TECHNICAL NOTE

Project EdgeConnex Ireland Limited
Subject Additional Information Response
Item no. 7 & 11

Ref. LB/20/11901TN02

Figure 3 Location of stormwater drain (including renumbering of ditches)

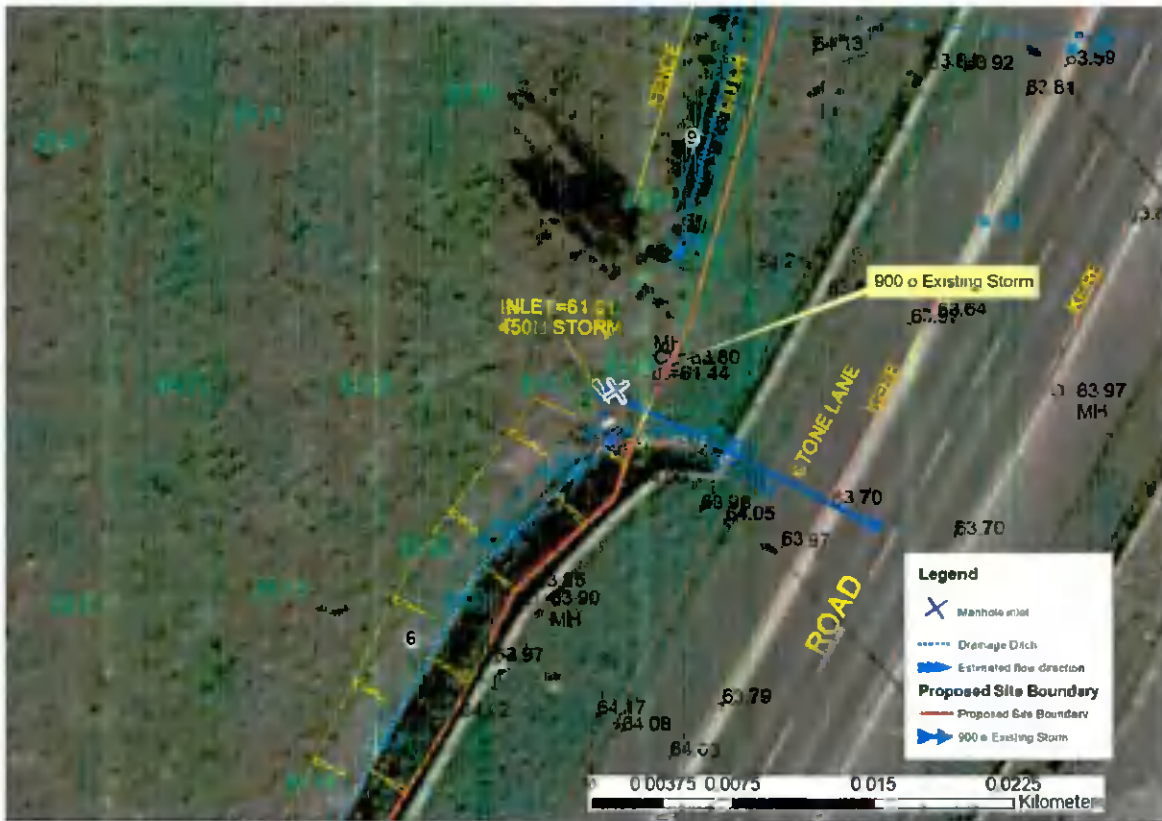
The response to Item 11 of the Additional Information request is not considered to be satisfactory. The applicant has indicated that there is water present in some of the ditches on the site and that culverts are also present. The applicant is requested to provide a strategy for removing the culverts and also for reinstating any potential watercourses. The filling in of any ditches should be justified in terms of how it would not impact the wider network negatively.

In the context of the above that applicant is requested to provide a strategy for the site, which seeks to remove culverts and restore potential watercourses. Where ditches are currently dry, the applicant is requested to demonstrate how their removal would not impact on the wider network.!

It is acknowledged that the development of this greenfield site will result in the infilling of some pre-existing agricultural drainage ditches that previously drained the site. These ditches facilitate the draining surface waters primarily to ground, or during extended periods of heavy rainfall drain into Field Ditch 6. It has been clarified (as part of this further information response) that this Field Ditch 6 in fact discharges to an existing 450 diameter storm inlet that connects to the existing 900 diameter storm drain in the bed of the R120 at the location of Manhole Inlet 2. This is clarified by topographical survey of the site as clarified in the above discussion and shown in detail on Figure 3 and Figure 4 below.

To clarify in respect of the culverts, the identified Culverts 2, 3, 4, are beyond the site and effectively in 3rd party ownership and it is not proposed to modify or remove these culverts. This has been confirmed by the georeferenced site boundary provided by the project Architect Henry J Lyons and project Civil Engineers Pinnacle Consulting Engineers.

There is only 1 no. culvert (shown as Culvert 1) within the site boundary. The culvert inlet is within the boundary and the outlet located at the boundary. To the north of Culvert 1, the eastern Field Ditch 6 lies outside of the property boundary (redline).

While it is acknowledged that Objective 4 of Policy G3 is to uncover existing culverts and restore the watercourse to acceptable ecological standards and for the passage of fish, where possible. The proposed landscaping berms will be located at Culvert 1, therefore it is not possible to replace this culvert with an open ditch. Culvert 1 will be replaced by an extended culvert suitably sized to current Office of Public Works (OPW) guidance in accordance with Section 50 of the Arterial Drainage Act 1945. The Clarification-RFI Response prepared by Pinnacle Consulting Engineers addresses the detail on the culvert design.
